Addison Townhomes - Map - 1994

**Re: Addison Townhomes
Intersection Sight Distance Recommendations**

PRELIMINARY SITE PLAN

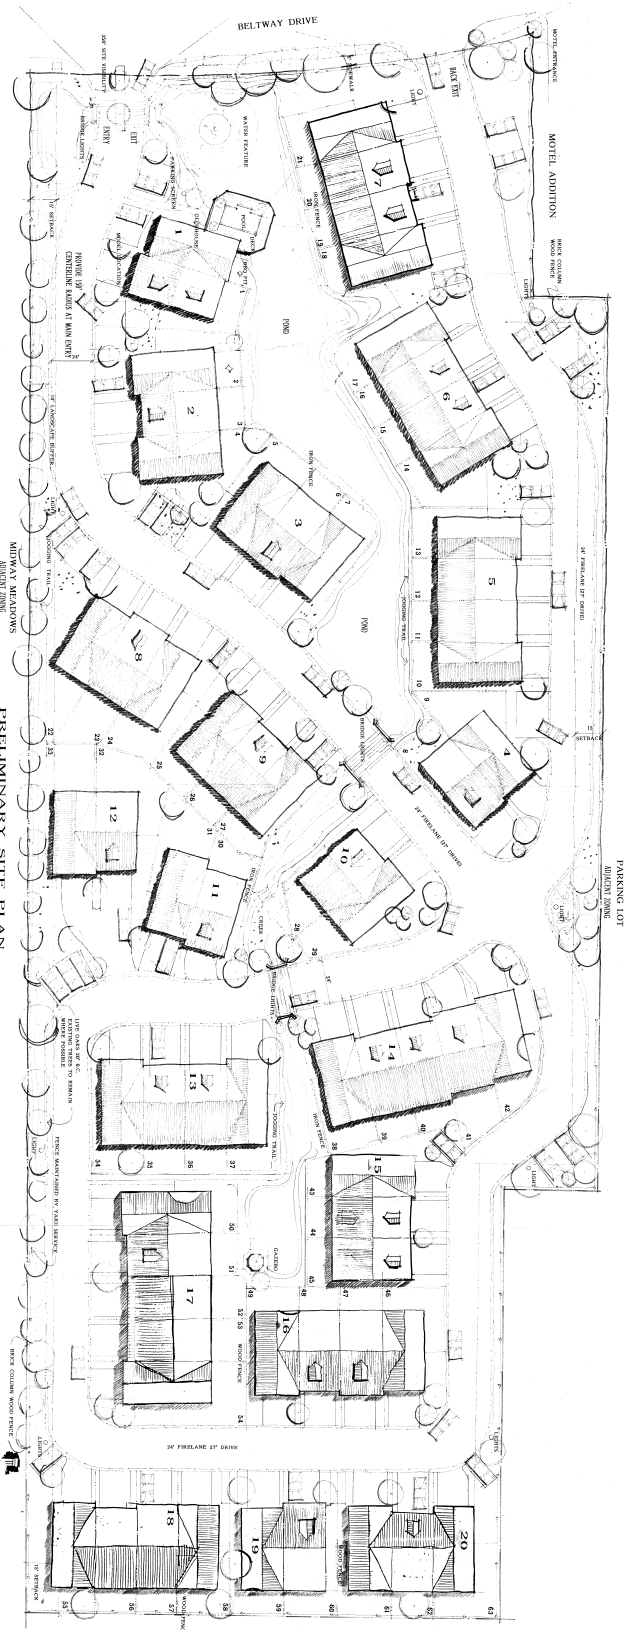
In addition to requiring the clear vision triangles described above, it is our recommendation that an additional area remain clear of visual obstructions near the interior street intersections, just as they are typically required at all public street intersections throughout the Town of Addison. The town requires that 35 foot by 35 foot clear vision triangles be provided at every intersection of two or more public streets and at intersections of a private street or driveway and a public street. There are many reasons for providing this additional clearance, one of which is to provide better visibility of and for pedestrians approaching the intersection, particularly where this type of traffic is not expected to be present. Within a self contained residential development, travel speeds are generally much lower and pedestrian traffic should be expected. Still, a smaller version of the Town's standard vision clearance triangle should, in our opinion, be provided. We recommend that the size of this triangle be 25 feet by 25 feet, as illustrated in Exhibit B and, as with the first requirement, before making this recommendation, we applied this requirement to each interior intersection shown on the site plan.

Subject to the developer's agreement to the sight distance - related requirements suggested herein, Huitt-Zollars believes that the proposed site plan will provide for safe and efficient circulation through the development. We appreciate the opportunity to respond to your concerns about sight distance within the Addison Townhome development and hope that we have addressed them to the extent you had originally anticipated. If not, please call me and let me know.
